Your ref : 2016/2700/P + 2723/L

Application references 2016/2700/P + 2016/2723/L : extensions to 8 Prince Albert Road, Camden

Representations on behalf of Mr and Mrs Carroll : 7 Prince Albert Road, Camden

Proposed Rear Elevation

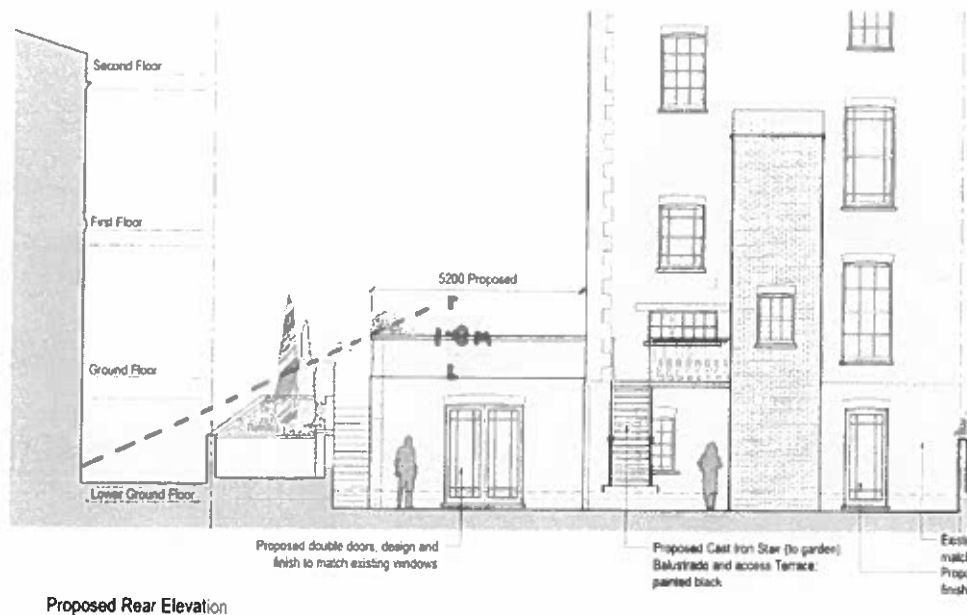
The proposals have a direct, adverse impact on the residential amenity of no 7 by virtue of overlooking and loss of privacy caused by the roof terrace proposed. As the photographs below illustrate, no 7 has habitable room windows facing no 8 on its side elevation at lower ground, ground and first floor levels. These windows directly face no 8 and as the diagram above demonstrates, a person standing on the roof terrace will be able to see directly into both sets of windows which serve main habitable rooms. The planter proposed presumably has the function of keeping people away from the shared boundary but as the diagram above demonstrates, it is not sufficient to prevent a loss of privacy occurring. The occupiers of no 7 currently have only a plain gable end facing them with no overlooking from no 8. The proposal introduces a significant degree of overlooking into their windows which is neither justified nor necessary.

The roof terrace should be deleted from the scheme in its entirety and if not, the applicant refused.

Lower ground floor side windows to no 7

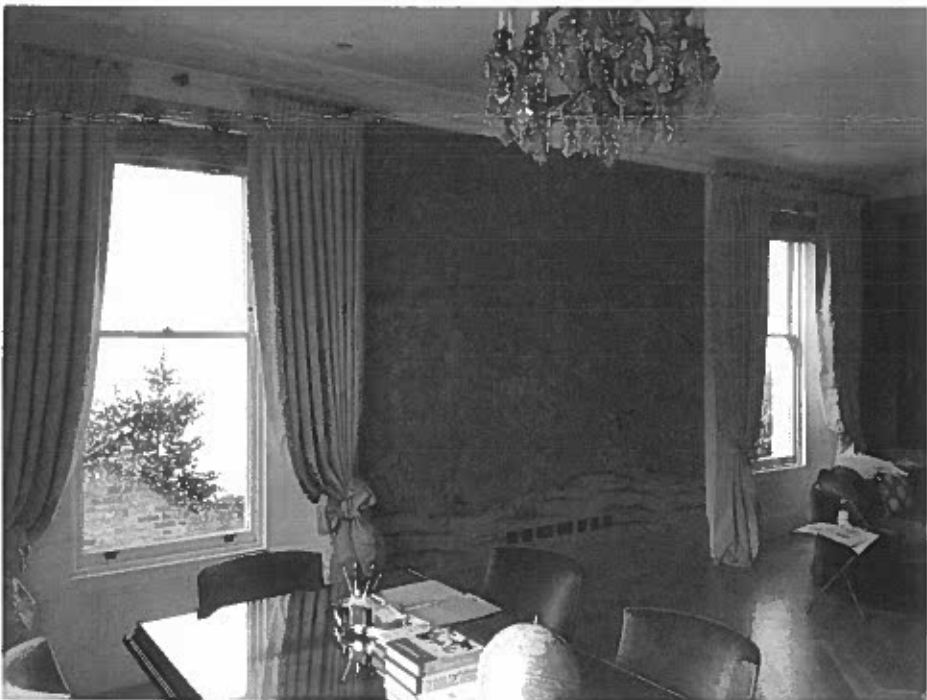
The roof terrace will also afford elevated views into the side and rear patio areas of no 7 which are currently secluded and private. These are areas where my clients can reasonably expect to enjoy some peace and quiet with their family during fine weather but this seclusion will be completely removed should the roof terrace proceed.

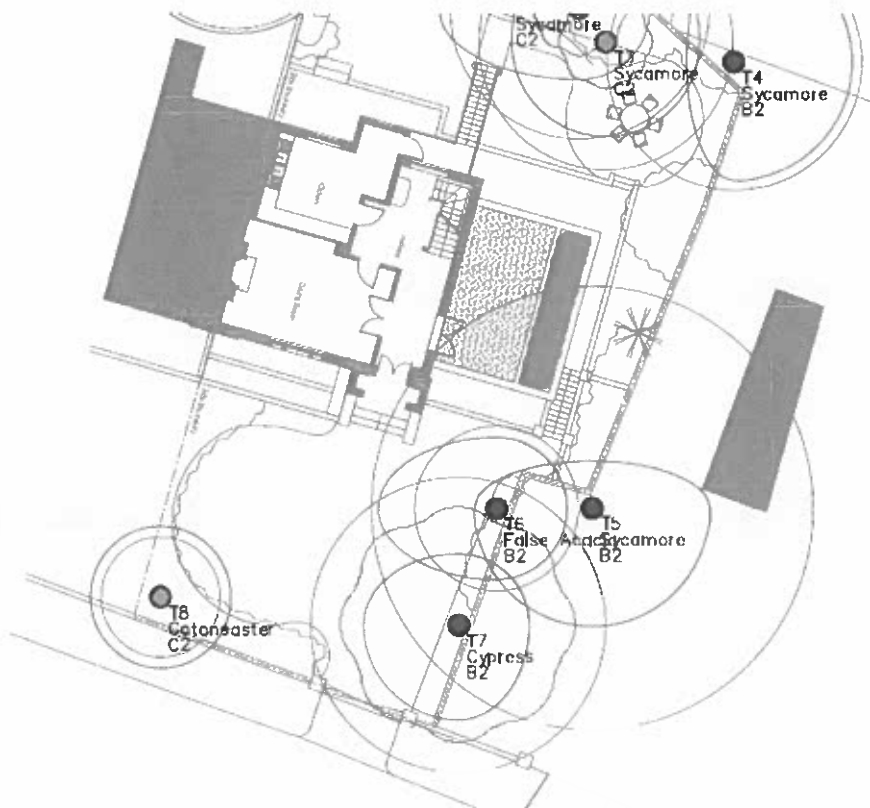
The only plan available which shows the relationship of the extension to no 7 is the one above taken from the applicant's tree constraint plan. My clients are concerned about the extent to which the extension is encroaching towards their property boundary. At its closest point, this will only be 2.6m from the boundary wall. On the contrary, the property of our clients sits 4.2 m (approx.) from that wall.

In addition, whilst the applicant notes that the extension at no 8 is the same width as the neighbouring extension at no 9, the distance of the no 9 extension from the boundary wall

(between no 9 and no 10) is 3.6 m. This is an additional meter in comparison to the distance of the no 8 extension to the boundary wall (between no 8 and no 7).
